Department
for Transport

UK Response to questions raised in ACPE 09

Tuesday, 27 August 2024

Context of Paragraph 5.15 (d)

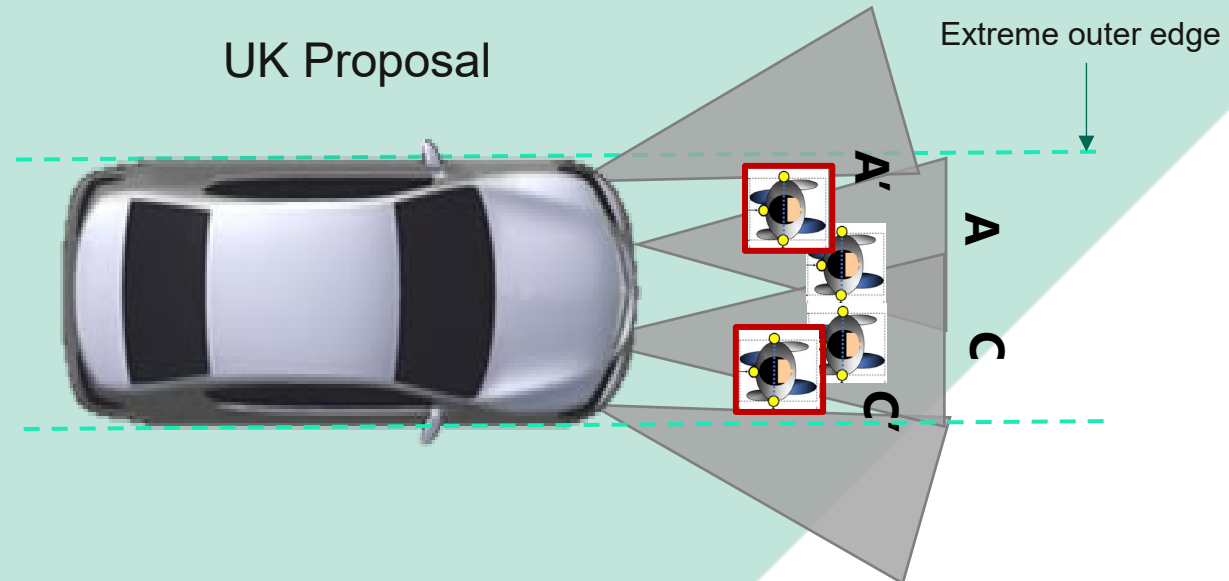
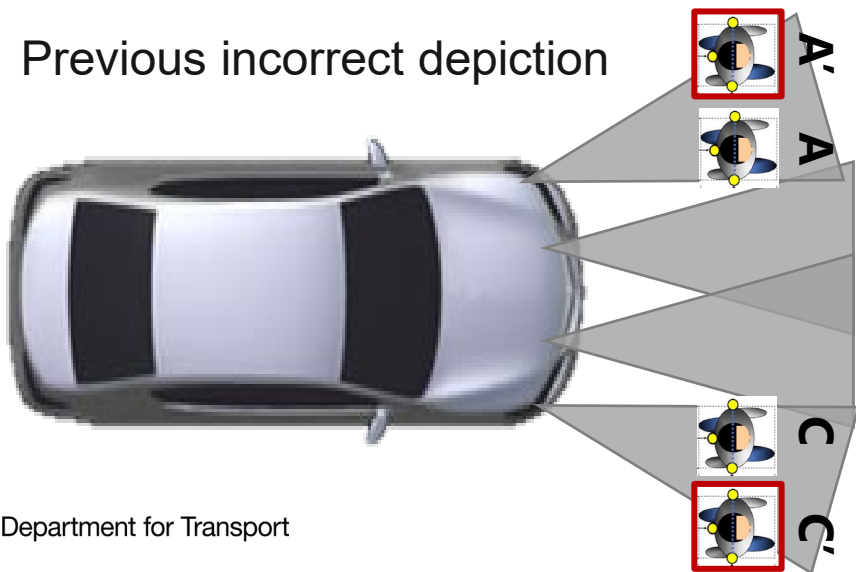
- Concern of extreme outer edge position:

“It is hard to detect pedestrian robustly by Sonar Sensor”. Sonar Sensors require obstacles to be detected by two sensors to avoid false positives. We can't distinguish between A and A' by one sonar operation data.

It is important to note “**devices for indirect vision**” are disregarded in the definition of “extreme outer edge”. This means the extreme outer edge can be in line with the surface of the body of the vehicle. Placing it closer to the vehicle than depicted in previously.

Proposed amendments to definitions

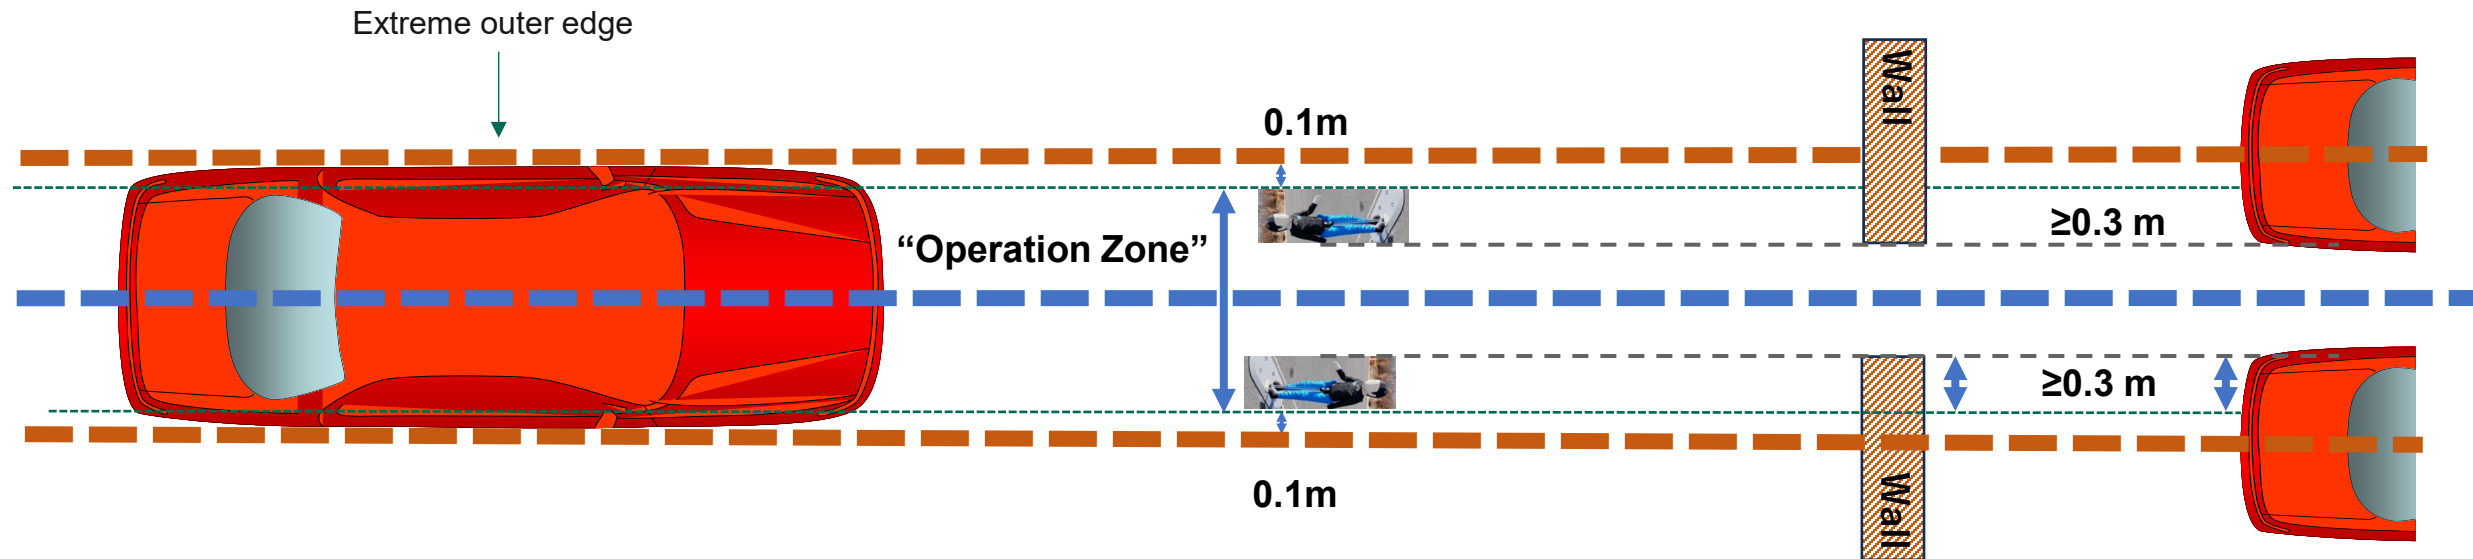
Definitions of operation zone are required to simplify and reference the obstacle(s) location, and where the obstacle is expected to be detected by the vehicle system(s).

[2.12] “Operation Zone” means the area located between two longitudinal vertical planes located 0.1m inside the extreme outer edges of the vehicle.

(ii) In the case of a vehicle or wall obstacle, the lateral offset between the centreline of the obstacle and the centreline of the vehicle is not more than 0.2 m. The centre line of the obstacle is located between two vertical longitudinal planes defining the extreme outer edge of the vehicle, at least a width of [0.3]m of obstacle is located within the operation zone.

(iii) In the case of a pedestrian obstacle, the entire pedestrian obstacle is located between two vertical longitudinal planes which are 0.1m within the operation zone extreme outer edge of the vehicle.
